**LEXINGTON-FAYETTE URBAN COUNTY  
GOVERNMENT CONTRACT CHANGE ORDER**  
Page 1 of 2

Date:	June 16, 2015
Project:	Senior Citizen Center Construction
Location:	Lexington
Contract No.	227-2014
Original Contract Amt.	\$8,882,900.00
Cumulative Amount of Previous Change Orders	\$228,161.07
Percent Change - Previous Change Orders	2.57%
Total Contract Amount Prior to this Change Order	\$9,111,061.07
Change Order No.	18

Proposal for Remediation of Subgrade Conditions  
at Paved Areas for Vehicle Traffic and Parking

PROJECT NAME:	LFUCG Senior Citizens' Center
PROJECT NUMBER:	201333
SUBJECT:	Parking Subgrade Remediation - Revised
DUE DATE:	6/25/2015
ID:	PR-018
SENDER ID:	
INITIATED BY:	Harding Dowell
REASONS:	Field Conditions
DISCIPLINE:	Civil Site
STATUS:	Closed
COP STATUS:	Not Received
CONTRACT:	Construction Services for Replacement Senior Citizens Center

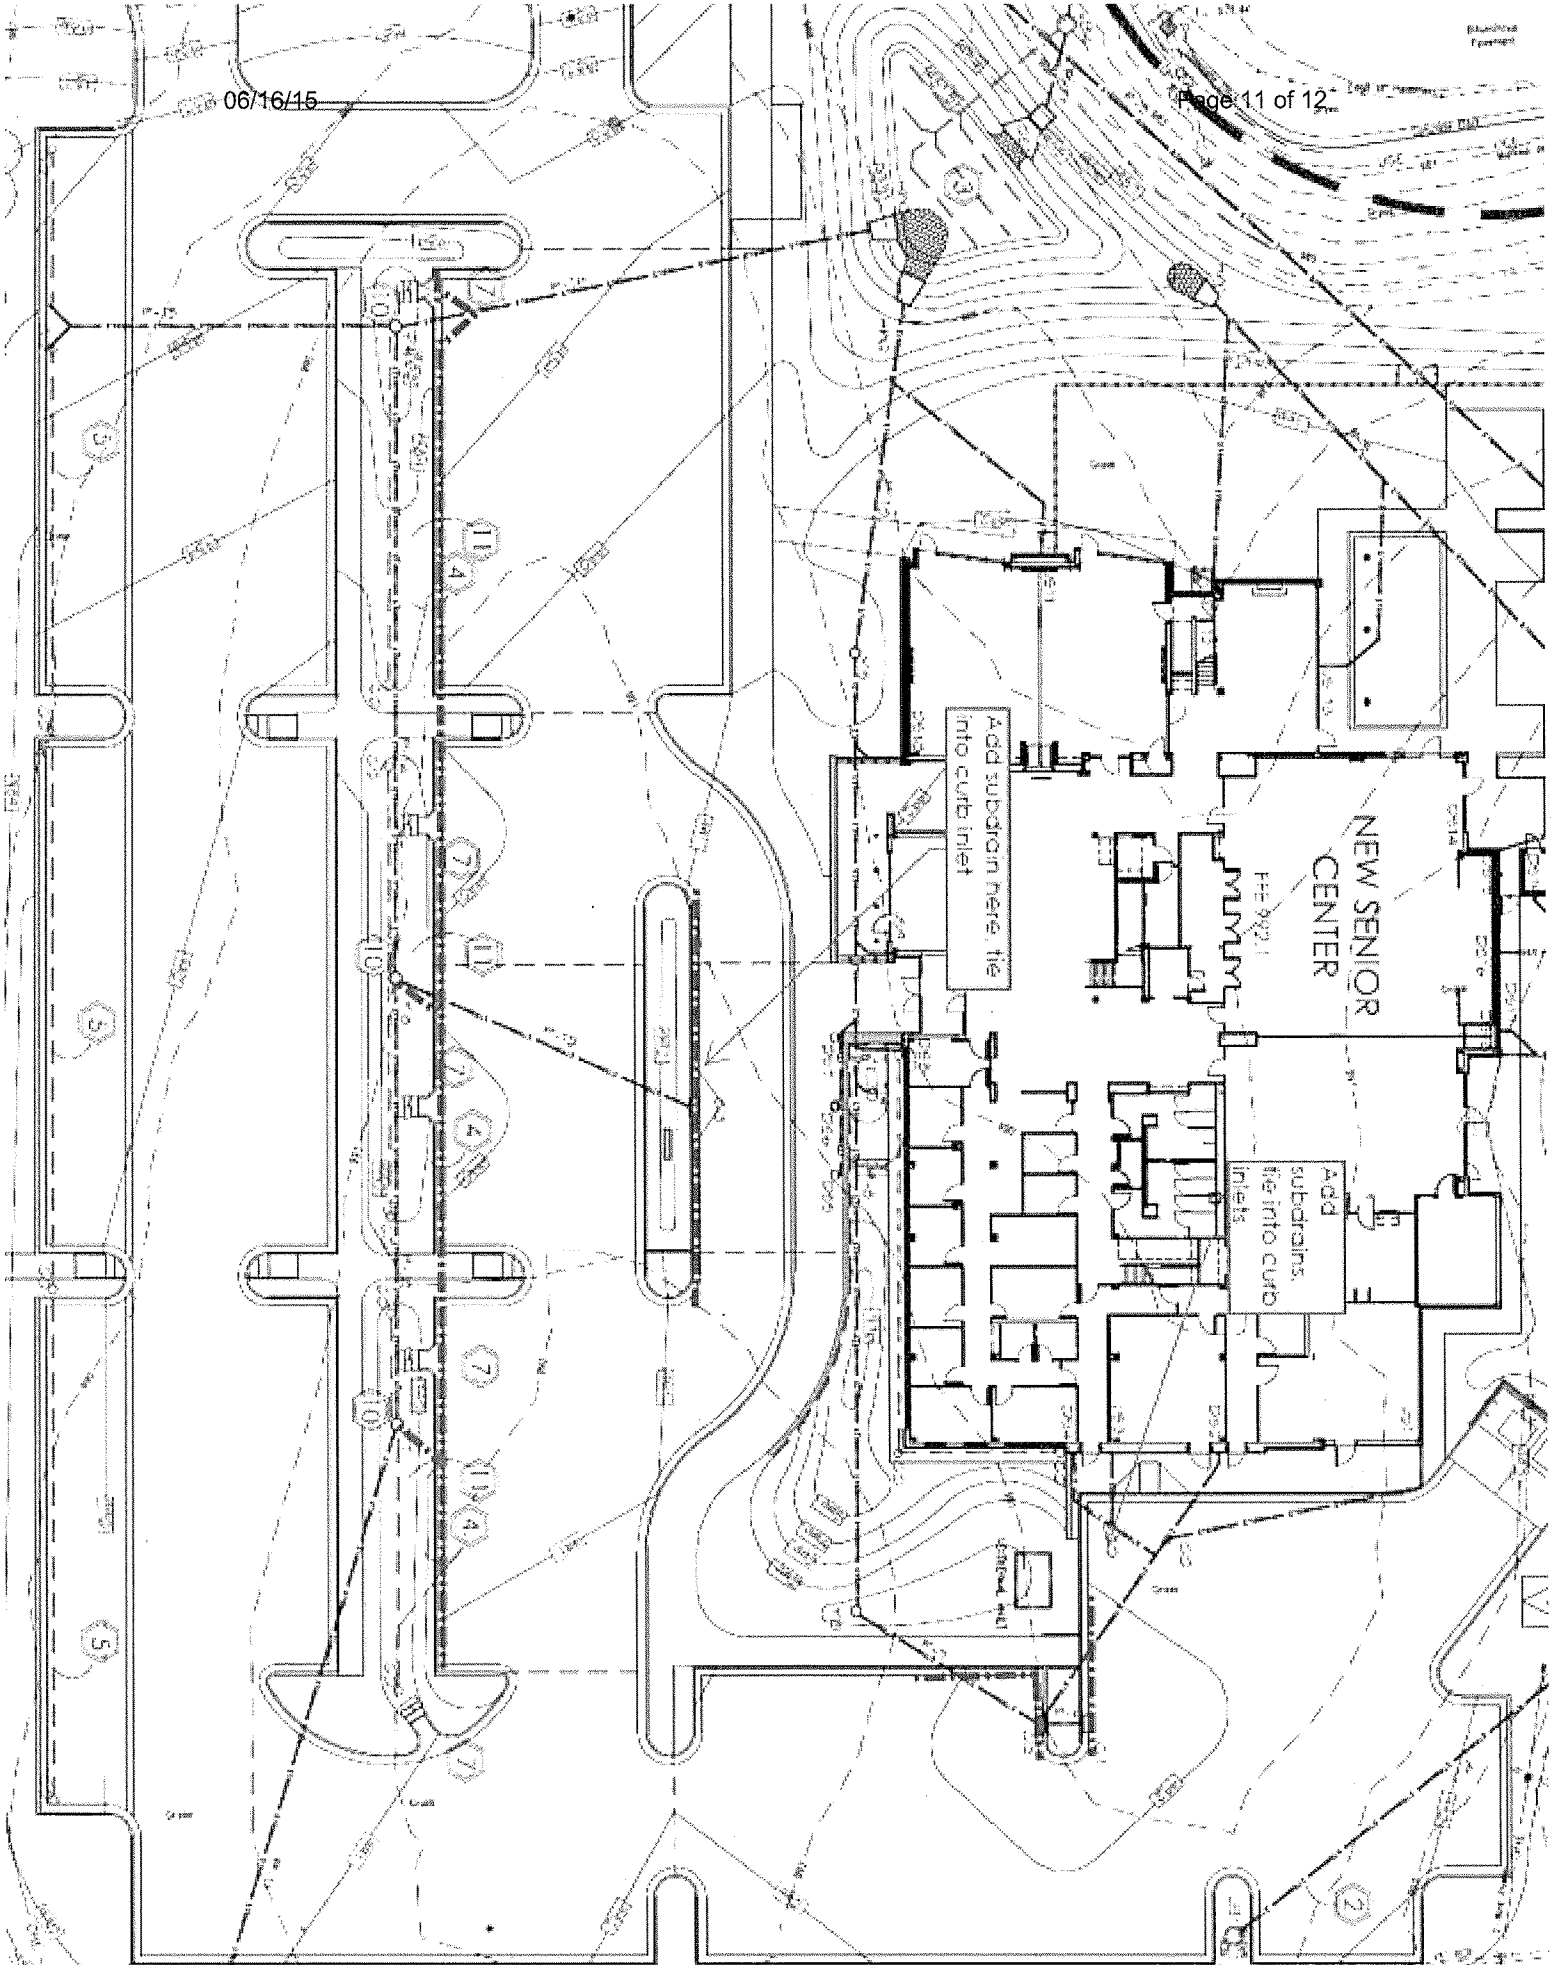
As a revision to Cardno's recommendation Option 1, one layer of woven high performance geosynthetic fabric replaces the lowest layers of filter fabric and geogrid noted in the attached document. This revision is illustrated in the attached profile section by Element Design and shall be included in the pricing.

Additionally, 6-inch diameter subdrains shall be included as noted in the plan drawing by Element Design. Subdrains shall tie into adjacent storm water structures.
